# Access Compliance Report

## Public Rights-of-Way

### (Curb Ramps)

Intersection ID: 12792	Main Street: E_HILL_ST	Cross Street: S_TRYON_ST	Location: E
ADA ID: 65F6B9DBF603	Ramp Type: Perpendicular	Initial Pass/Fail: Fail	Overall Compliance: No
Severity Score: 12.5			
Codes/Mitigation Info/Possible Solution		Field Measurements/Component Compliance

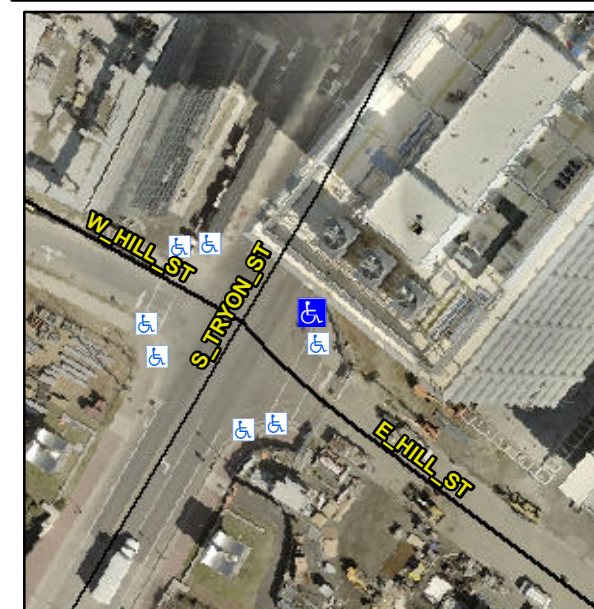
**Remove & Replace Entire Ramp.**

**Not Found, R304.2.2**

Compliance	Description	Data	Compliance	Description	Data
N/A	Ramp Length (in)	77.0	No	Ramp Slope (%)	9.3
Yes	Ramp Width (in)	48.0	Yes	Ramp XSlope (%)	1.4
N/A	Flare Type LT	N/A	N/A	Flare Type RT	N/A
N/A	Flare Slope LT (%)	N/A	N/A	Flare Slope RT (%)	N/A
N/A	Flare Traversable LT?	N/A	N/A	Flare Traversable RT?	N/A
N/A	Landing Length (in)	N/A	N/A	DWS Provided?	N/A
N/A	Landing Width (in)	N/A	N/A	DWS Contrast?	N/A
N/A	Landing Slope (%)	N/A	N/A	DWS Length (in)	N/A
N/A	Landing X Slope (%)	N/A	N/A	DWS Full Width?	N/A
N/A	Landing Curb? (Y/N)	N/A	N/A	DWS Offset (in)	N/A
N/A	Shared Landing?	N/A			
N/A	Gutter Ponding?	N/A	N/A	Gutter Slope (%)	N/A
N/A	Gutter Lip Ht (in)	N/A	N/A	Gutter X Slope (%)	N/A
N/A	Painted X Walk1?	No	N/A	Painted X Walk2?	N/A
	X Walk 1 Direction	To NW		X Walk 2 Direction	N/A
N/A	X Walk 1 Width (in)	N/A	N/A	X Walk 2 Width (in)	N/A
	X Walk 1 Slope (%)	3.2		X Walk 2 Slope (%)	N/A
	X Walk 1 X Slope (%)	1.2		X Walk 2 X Slope (%)	N/A
